# SERVICE BULLETIN

### **MANDATORY**

## CHECK OF ALLEN SCREW M8X100 IN THE CRANKCASE ON ROTAX® ENGINE TYPE 912/914 SB-912-047 SB-914-032

Check of allen screw M8X100 part no. 440427 in the crankcase on ROTAX® engine type 912/914.

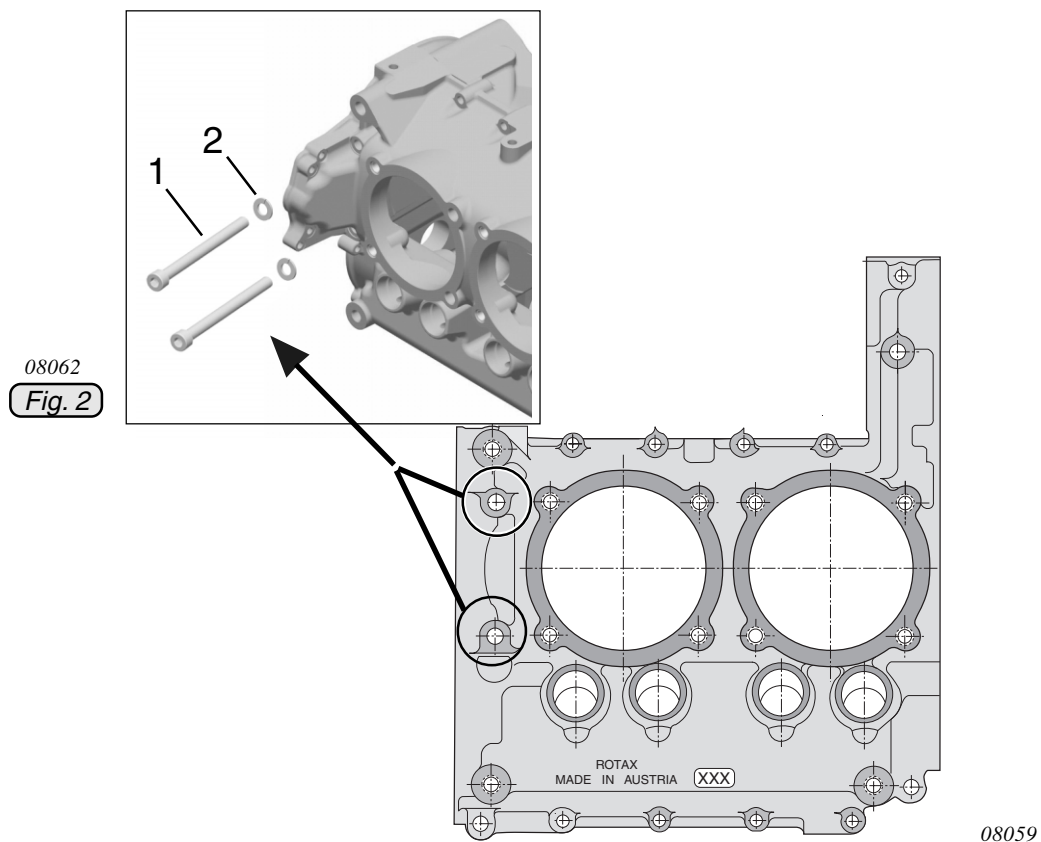
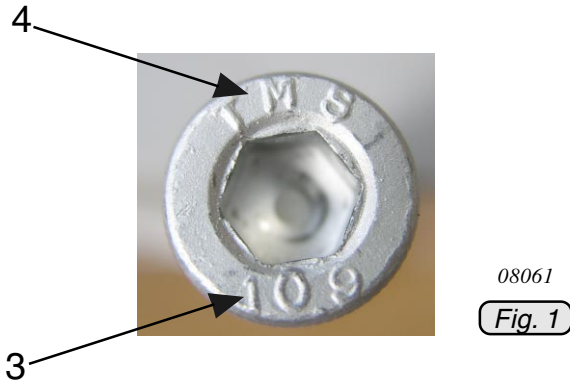
Only the 2 allen screws M8X100 (1) part no. 440427 are affected by the production deviation. They are installed in the crankcase on the cylinder side 1/3 between cylinder 3 and the electric starter.

Furthermore, only allen screws marked „TMS“ on the screw head are affected.

◆ **NOTE:** In addition to the quality marking 10.9 (3) the production code must be identified on the screw head. Allen screws with a production code of „TMS“ (4) may be affected and must be replaced in all cases.

- Replace affected allen screw (1) including lock washer (2). Tightening torque 30 Nm (265 in.lb.).

■ **CAUTION:** If both allen screws are affected and must be replaced, allen screws and lock washers must be replaced one at a time. Remove and replace the first allen screw and lock washer before loosening or removing the second screw. After the first screw and lock washer has been replaced, remove the second allen screw and install a new allen screw and lock washer.
